**ADDENDUM NO. 3.0**

**REPLACEMENT OF INDUSTRIAL AVENUE BRIDGE (NO. 025030) OVER UNNAMED  
STREAM PROJECT  
Cheshire, Connecticut**

**Addendum No. 3 Issued February 23, 2024**

CONSULTING ENGINEER: SLR CONSULTING INC. 2025-03-24  
 PROJECT NO. 11047.00059  
 DRAWING NO. STR-03

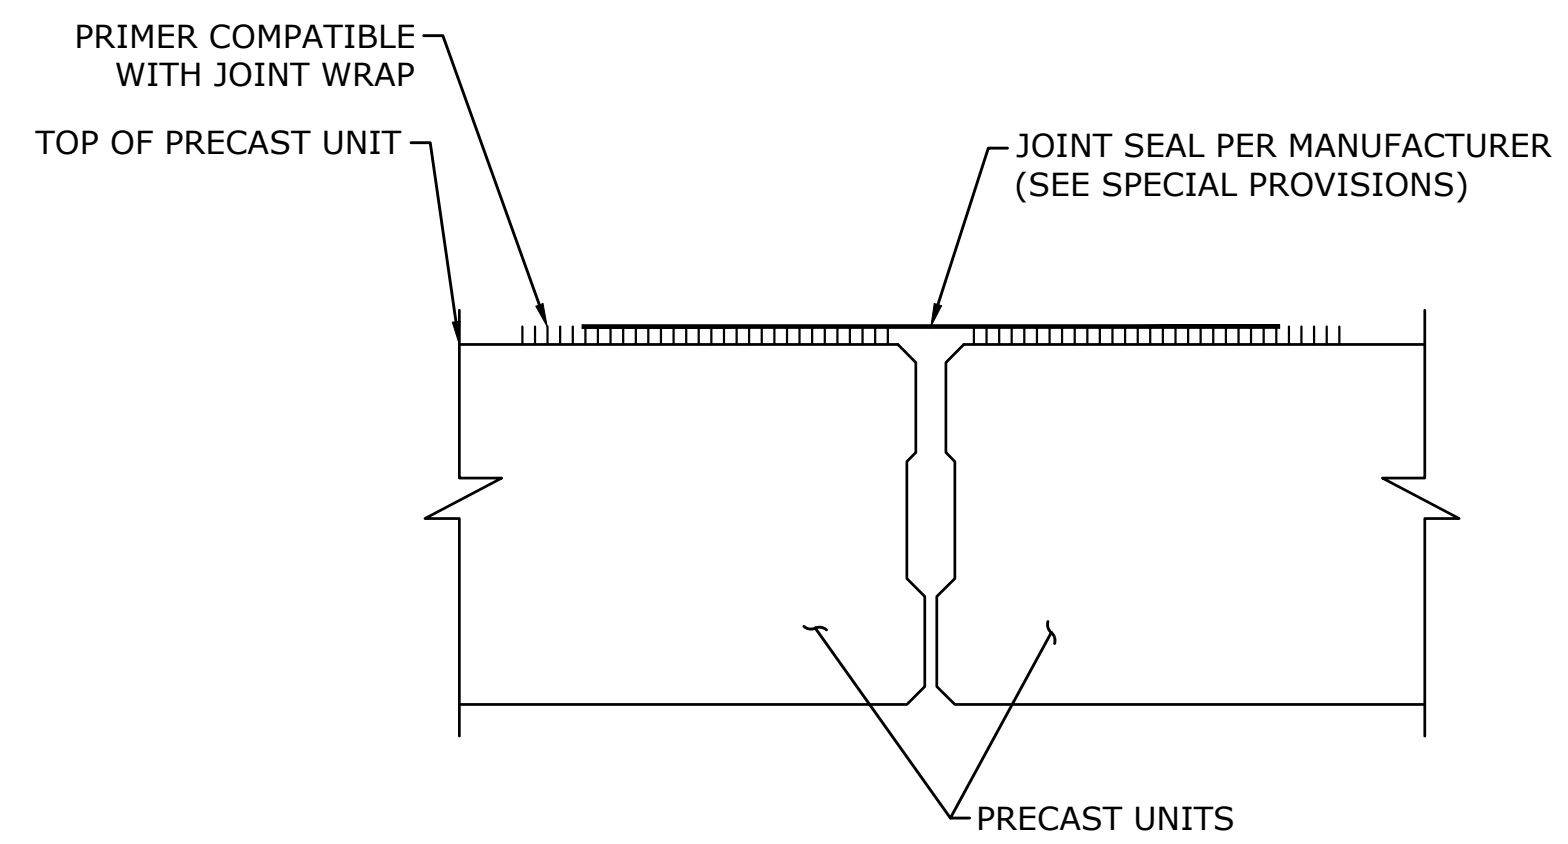
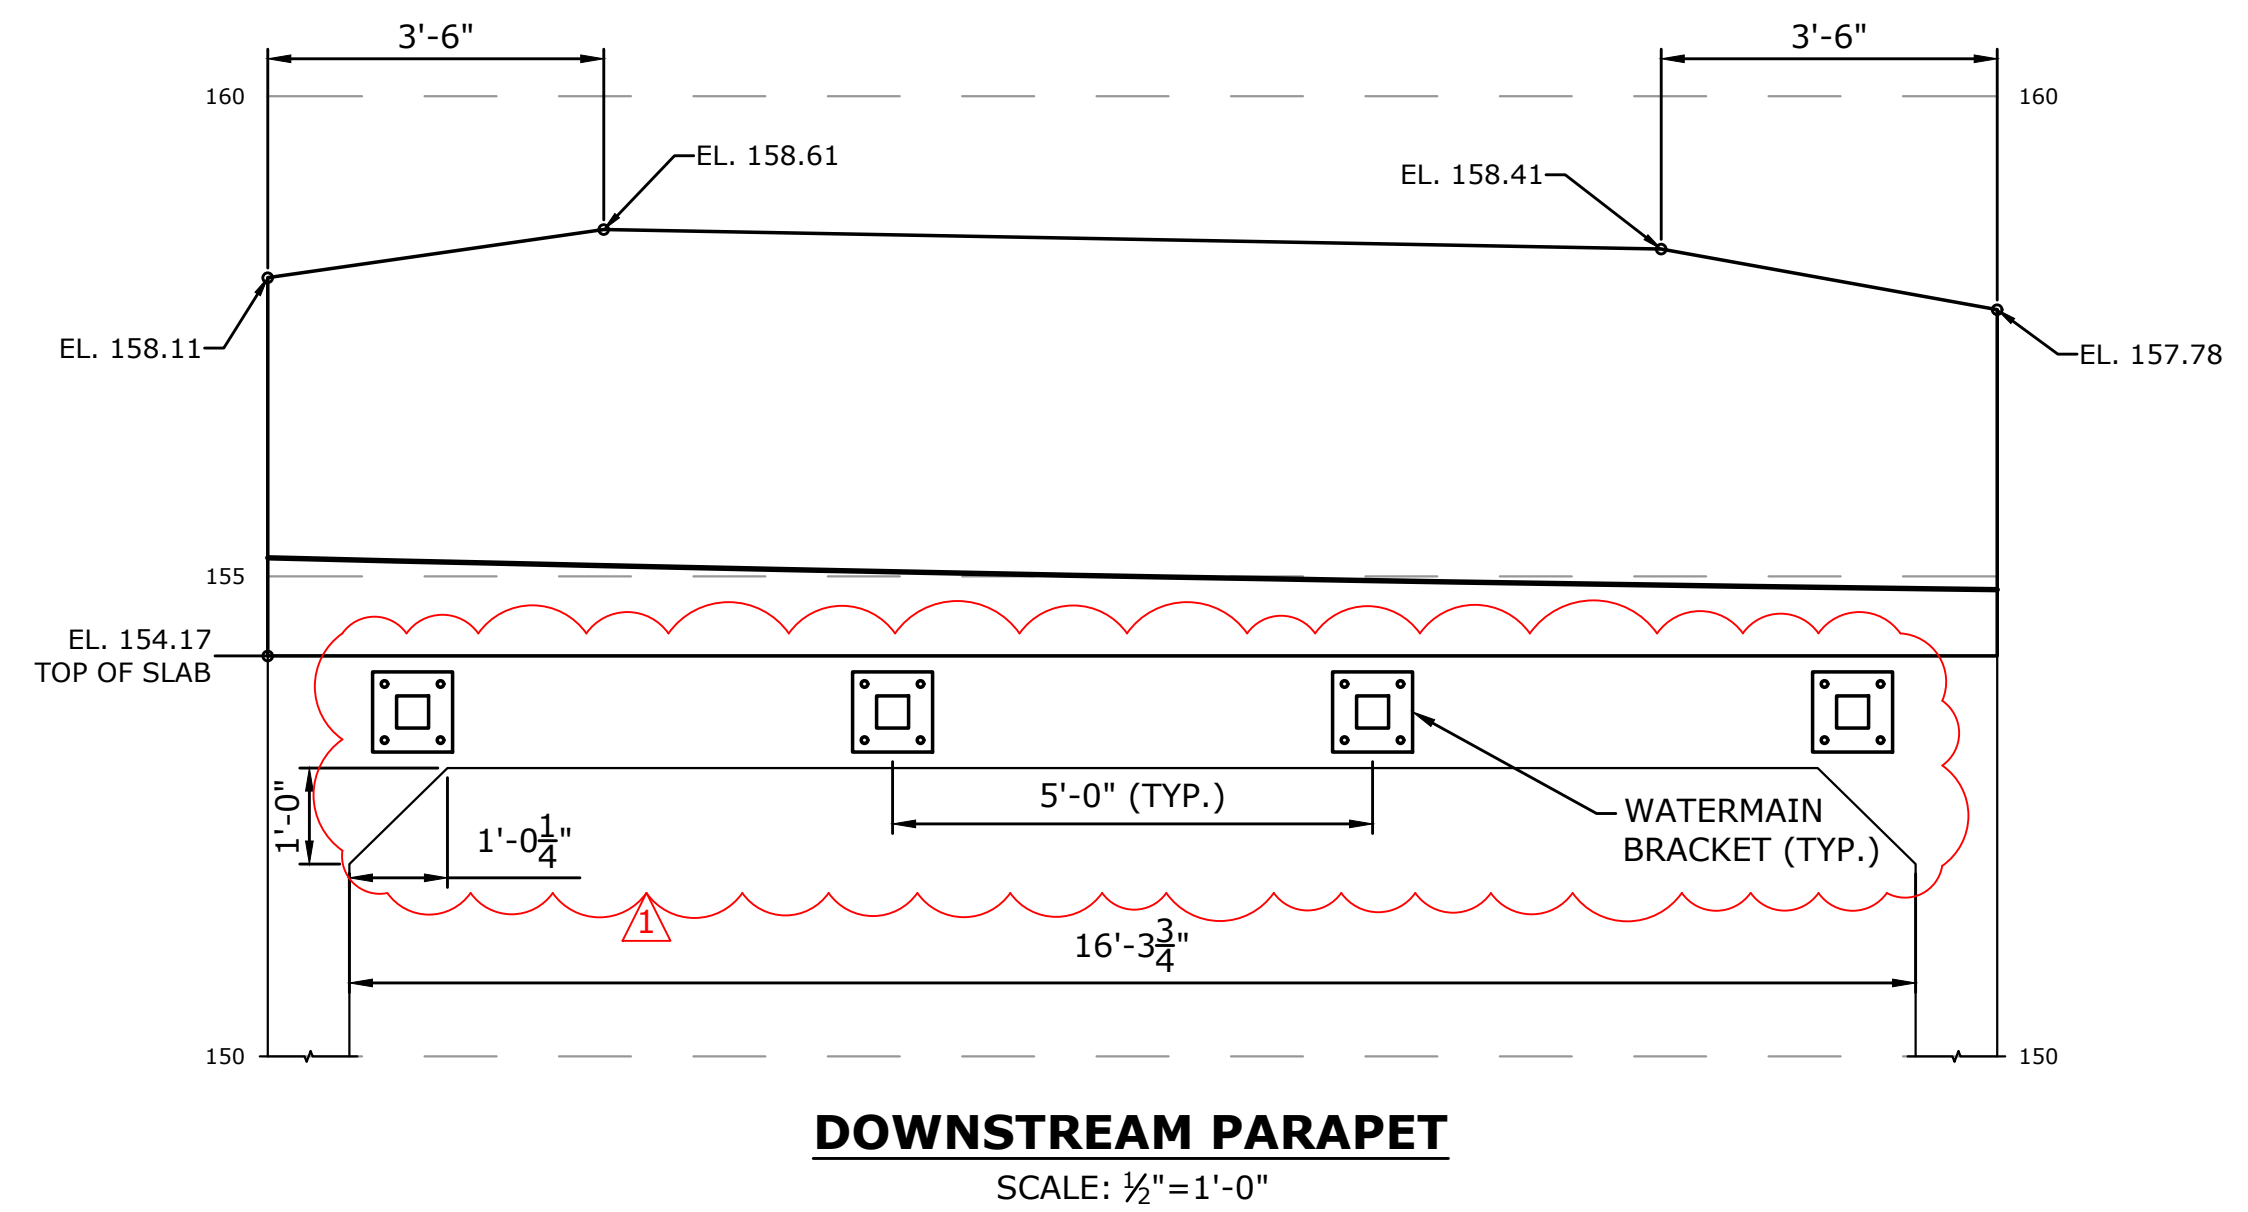
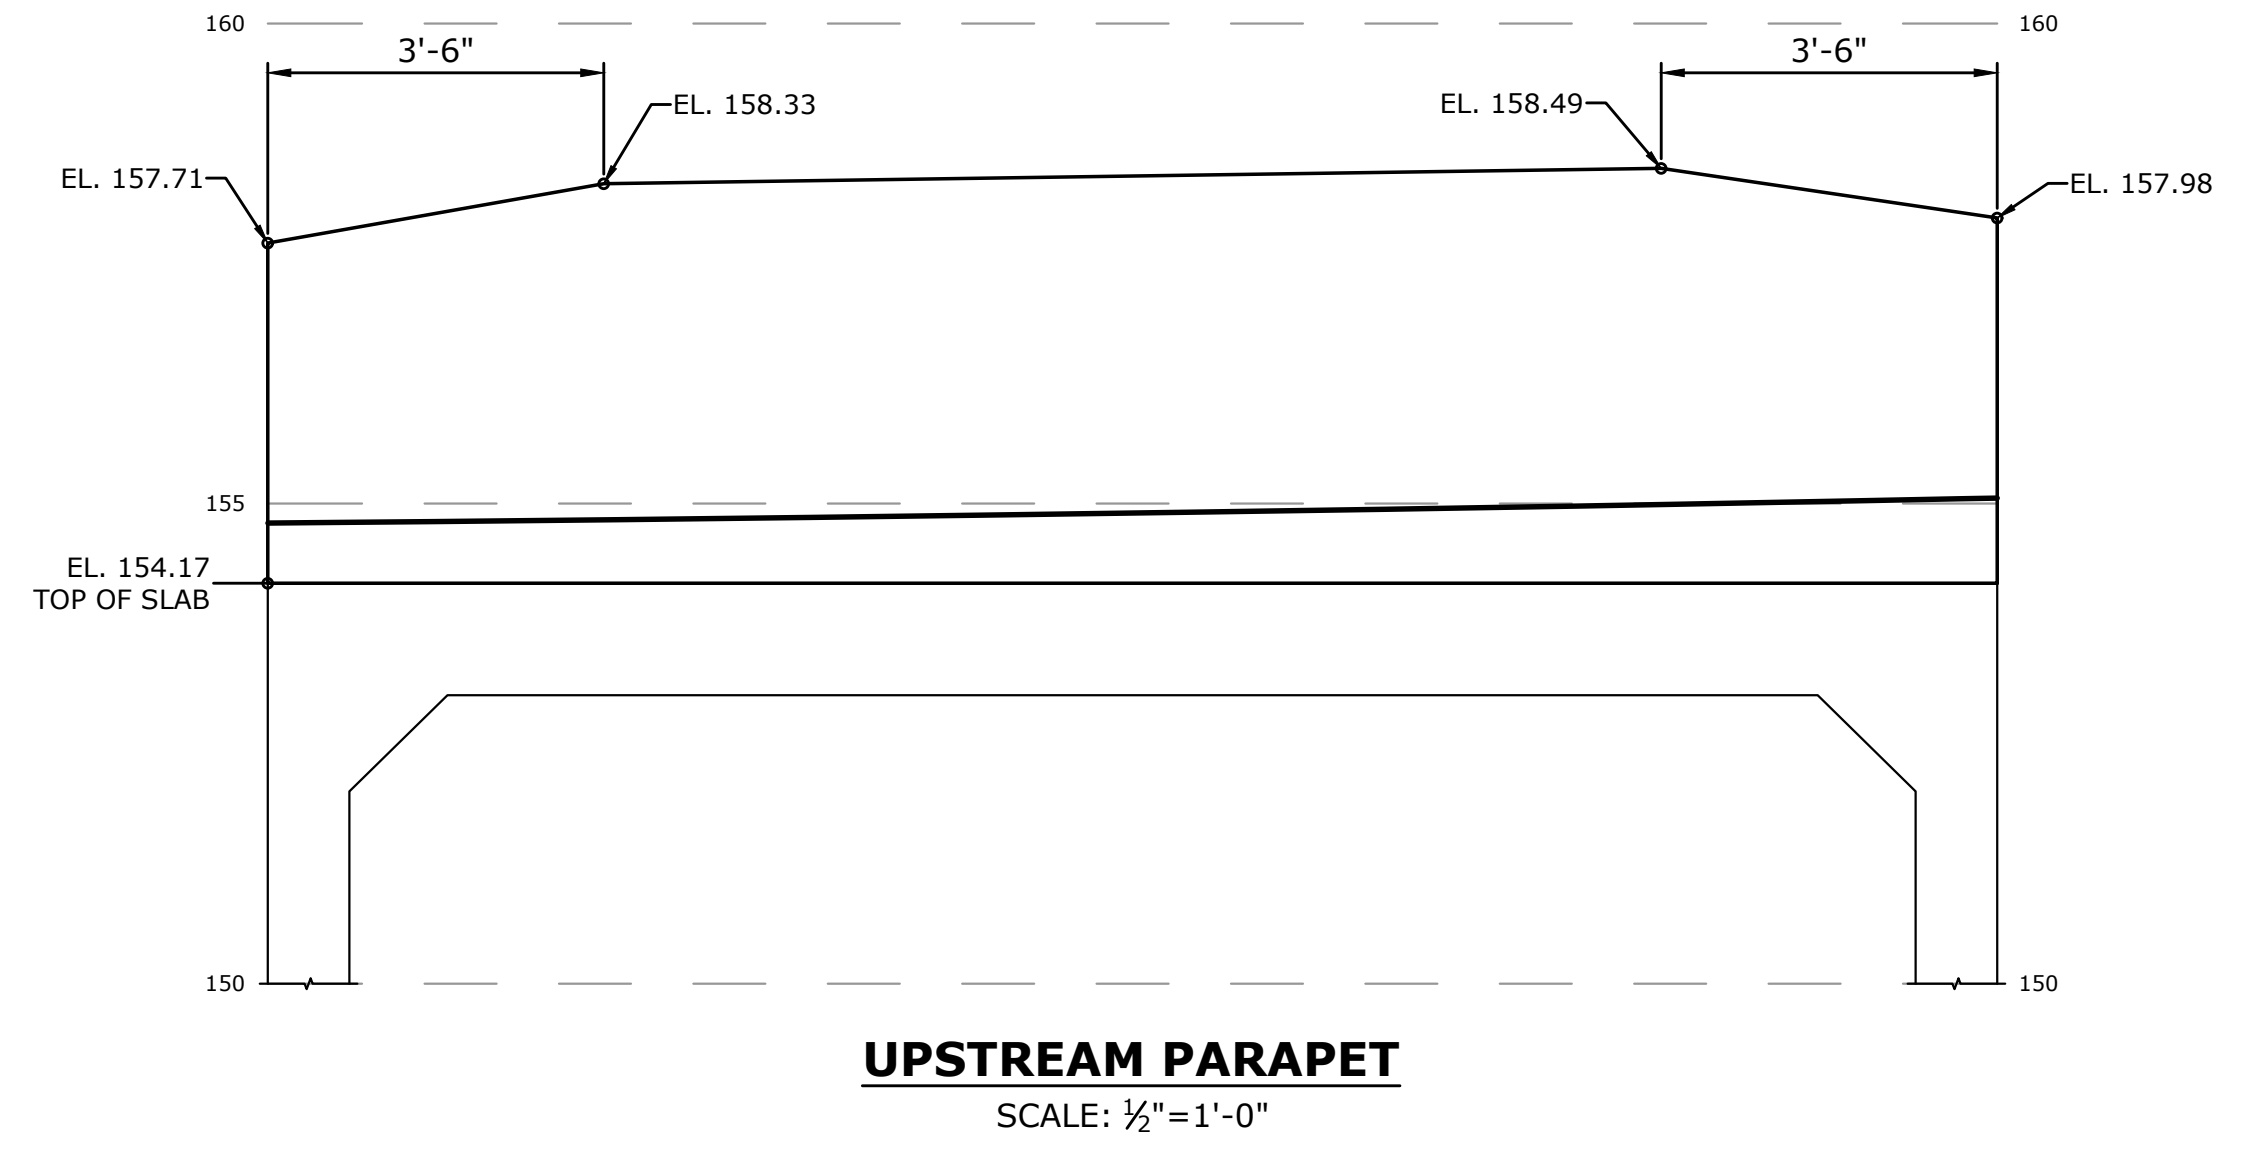
- Q5. Please provide the elevations at the top of the wingwalls as well as the detail for where the drainage pipes pass through the wingwall.**
- R5. See updated plan sheet STR-03.
